| Project                      | <b>IEEE 802.16 Broadband Wireless Access Working Group</b> < <a href="http://ieee802.org/16">http://ieee802.org/16</a> >  |  |
| Title                        | DL Traffic Channel Definition and Enhanced DL Resource Allocation for OFDMA PHY   |  |
| Re:                          | IEEE P802.16e/D5-2004   |  |
| Abstract                     | This contribution proposes to define semi-static traffic channels (or region) on the DL. The objective is to reduce the overhead in DL resource allocation.   |  |

Figure 1. Example of semi-static channel definition and DL access allocation to reduce overhead (The channels layout shown above is logical).

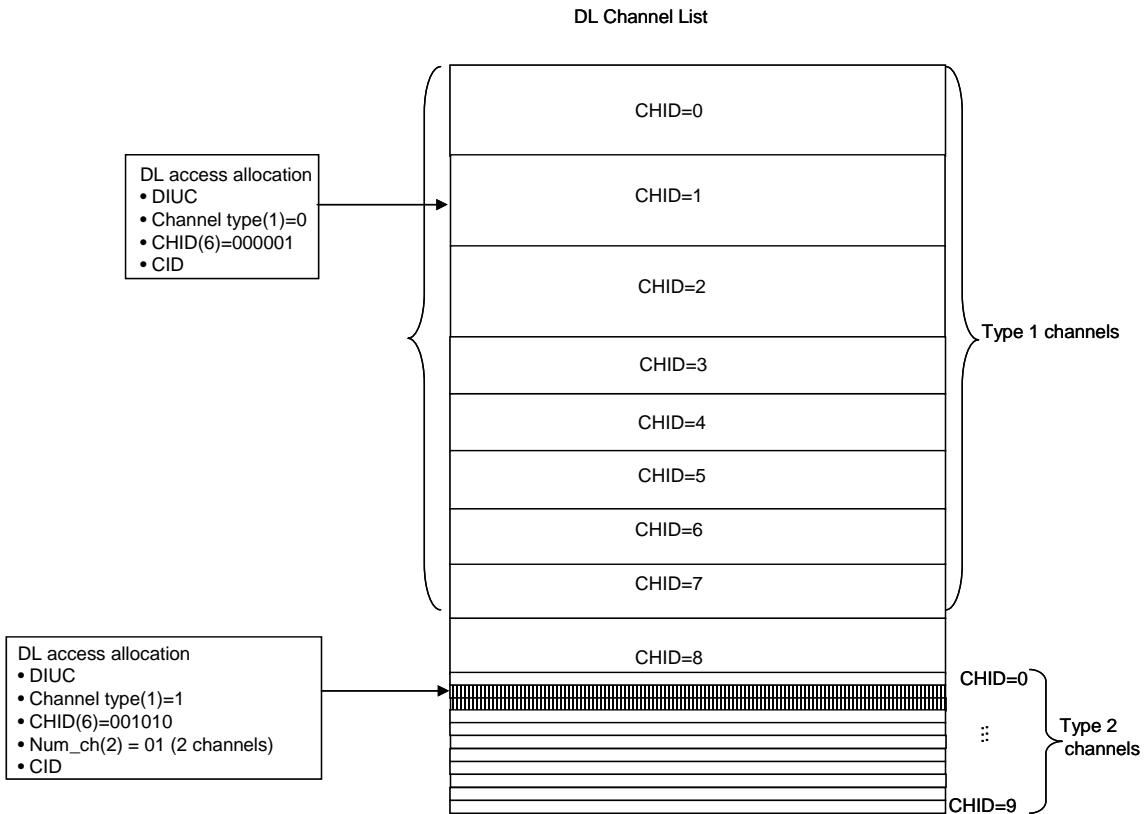
Figure 1 shows an example of the above scheme.

Using the above scheme, the total overhead involved in defining DL access regions is reduced from 560 bits to 140 bits (assume 20 Type 1 channels) or 180 bits (assume 20 Type 2 channels) if we assume 20 connections (CIDs) are scheduled in a frame.

Figure 2. Example of semi-static channel definition and DL access allocation for the case where CHID is omitted (The channels layout shown above is logical)

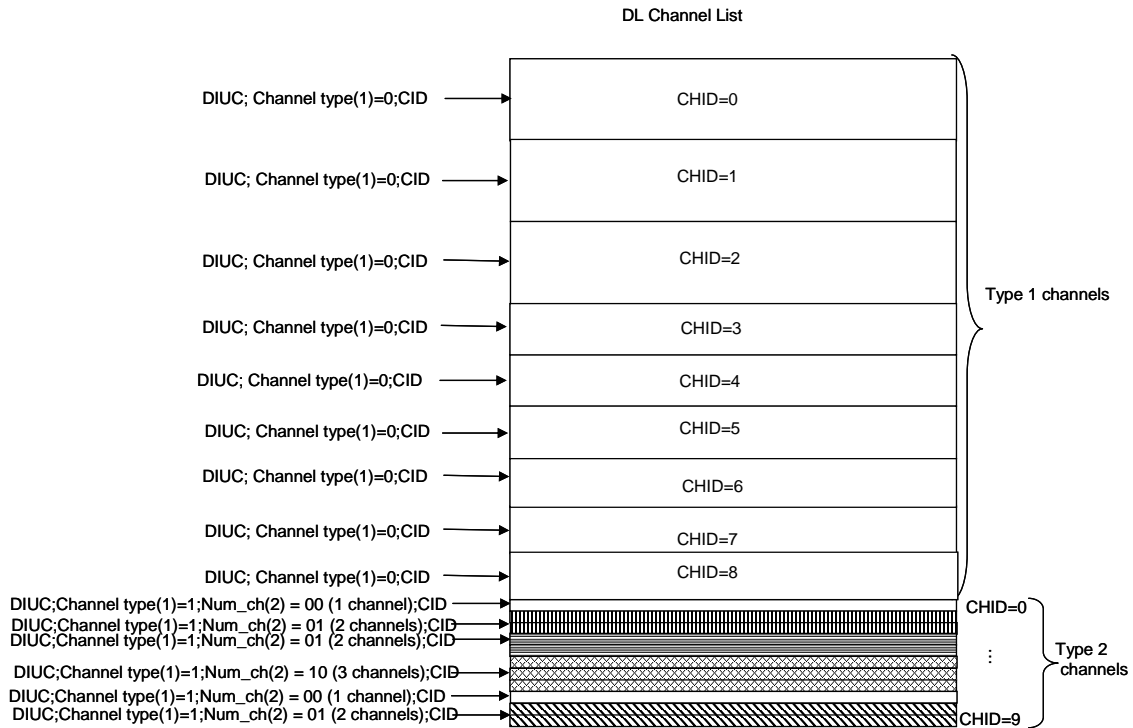
In fact, the overhead can be further reduced by omitting the CHID field in the DL access allocation. This is possible by setting the rule that each subsequent DL access allocation corresponds to the next increment of the CHID value of a particular channel type. This is illustrated in Figure 2. In this way, the overhead involved in defining DL access regions can be further reduced to 20 bits (assume 20 Type 1 channels) / 60 bits (assume 20 Type 2 channels), if we assume 20 connections (CIDs) are scheduled in a frame.

Figure 3. Example of semi-static channel definition and DL access allocation for the case where there is irregular assignment that overlaps with region defined for the semi-static channel (The channels layout shown above is logical)

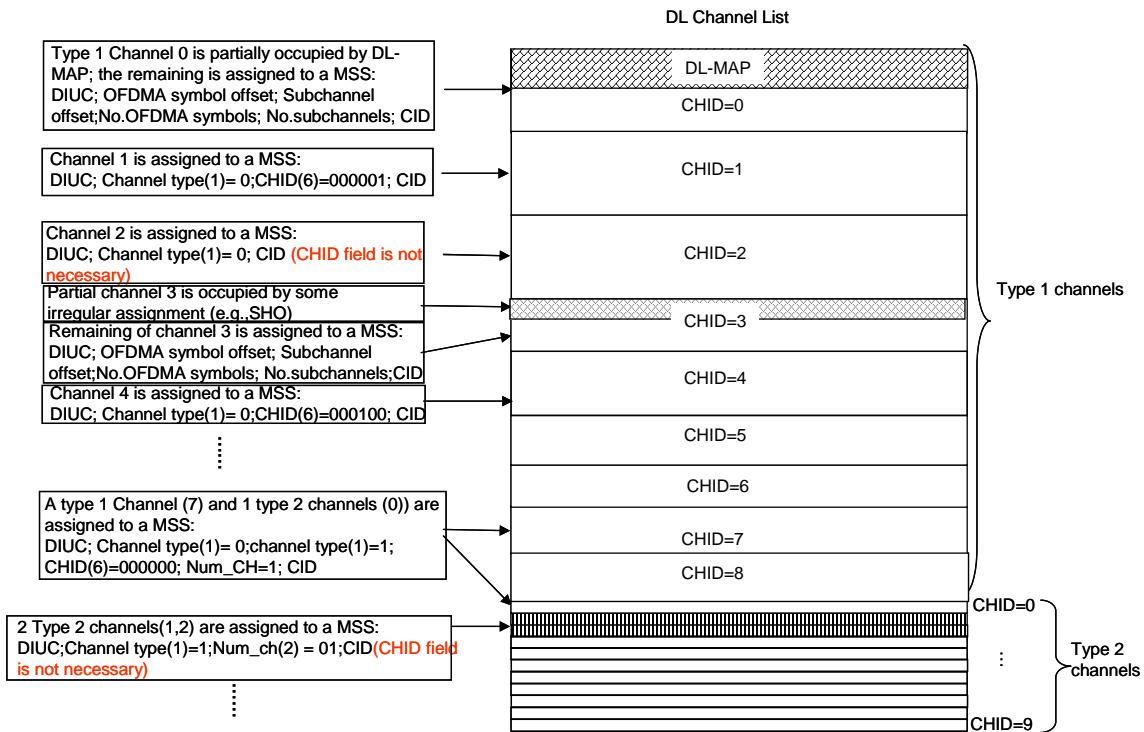
The case shown in Figure 2 above (i.e. CHID omission) may not always be possible under certain situation where the access region defined for certain semi-static channels is assigned to or overlapped with other ‘irregular’ region allocation, e.g. DL/UL-MAP, SHO zone. Under such situation, the CHID needs to be included for the next semi-static channel assignment following the ‘irregular’ region. For subsequent semi-static channel assignments, CHID can again be omitted. This is illustrated in Figure 3, which includes scenarios where DL-MAP occupies partially the region defined for Type 1 channel #0 and SHO region occupies partially the region defined for Type 1 channel #3. For the above 2 scenarios, CHID is required for the next semi-static channel assigned following the ‘irregular’ region.
